2010 Review and Evaluation of the Shiprock Remediation Strategy

January 2011

U.S. DEPARTMENT OF
ENERGY

Legacy
Management

Figure 5. Decrease in Groundwater Elevations in Terrace Alluvial Wells (March 2003—March 2010)

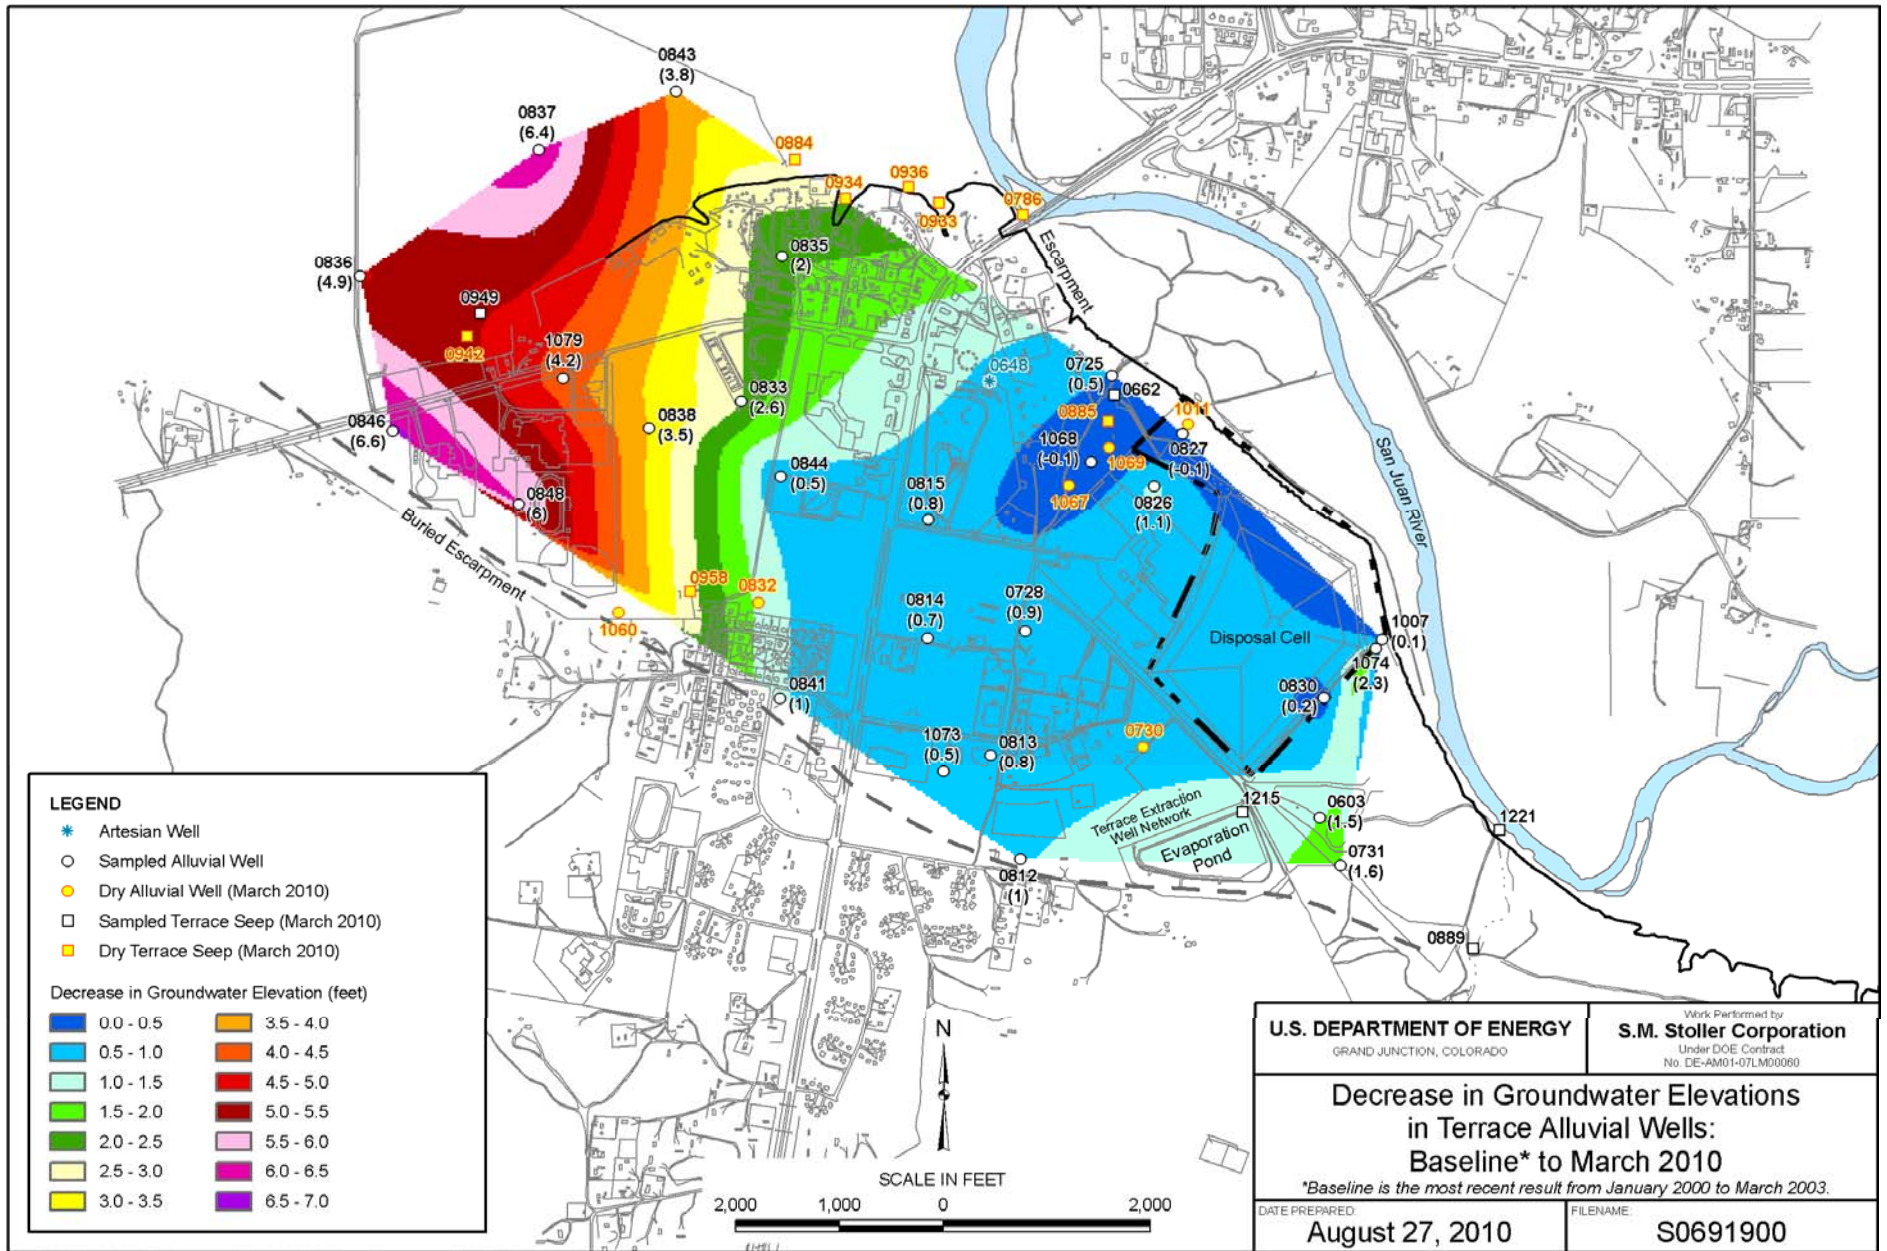
Comment 4. In paragraph 3 states that several monitoring wells and the environmental sampling data was utilized to evaluate the potential of adding wells to the remediation system, regardless of the past environmental data the DOE should have obtained water level measurements at all ground water monitoring wells prior to stating water levels are declining in the terrace.

DOE monitors water levels at most wells on a semiannual basis. Figure 5 of the revised strategy evaluation demonstrates the declines in terrace water levels for the subset of alluvial wells for which baseline (before March 2003) measurements are available.
